VALLEY OF THE WINDS

Response to TfNSW Amendment Report request for additional information

26 MARCH 2024

Figure 5-1 Construction workforce access routes to Girragulang Road Cluster: Regional accommodation scenario

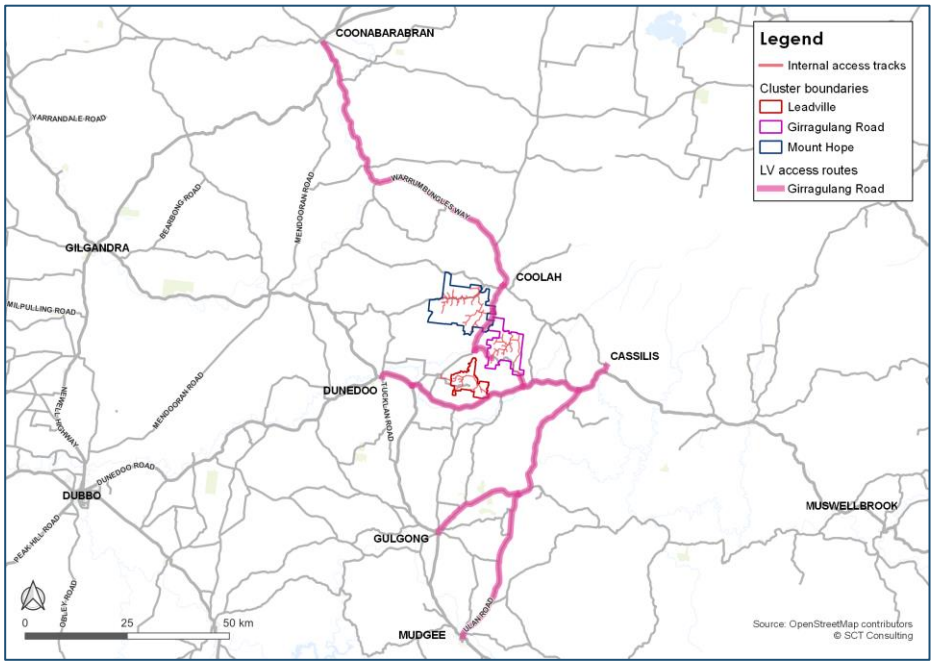
Under the regional accommodation scenario, the recommended short channelised right turn at the Golden Highway / Ulan Road intersection is due to light vehicles and shuttle buses returning to Gulgong and Mudgee in the PM peak hour along the access route from the Girragulang Road Cluster stated in the EIS and shown in **Figure 5-1**.

Figure 5-2 Construction workforce access routes to the worksite clusters: Centralised accommodation scenario

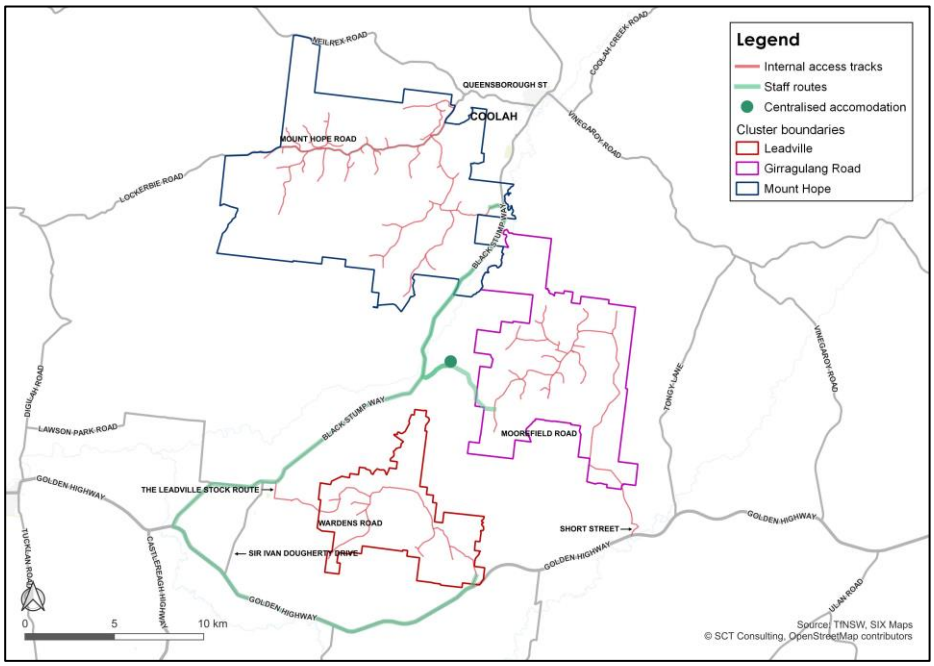
If a centralised accommodation camp is in use, as is intended by ACEN, Ulan Road would not be used and therefore no impact or upgrade would be required. The access routes to the cluster worksites for the centralised accommodation scenario are shown in **Figure 5-2**. Construction workforce traffic would only impact the Black Stump Way and Leadville Cluster Access Road intersections on the Golden Highway. The left turn into the Leadville Cluster Access Road in the AM peak hour would not warrant an auxiliary left turn at the intersection (see **Figure C-9** and **Figure C-10** in **Appendix C**) and the right turn movement at the Black Stump Way in the PM peak hour would be accommodated in the existing channelised right turn lane.
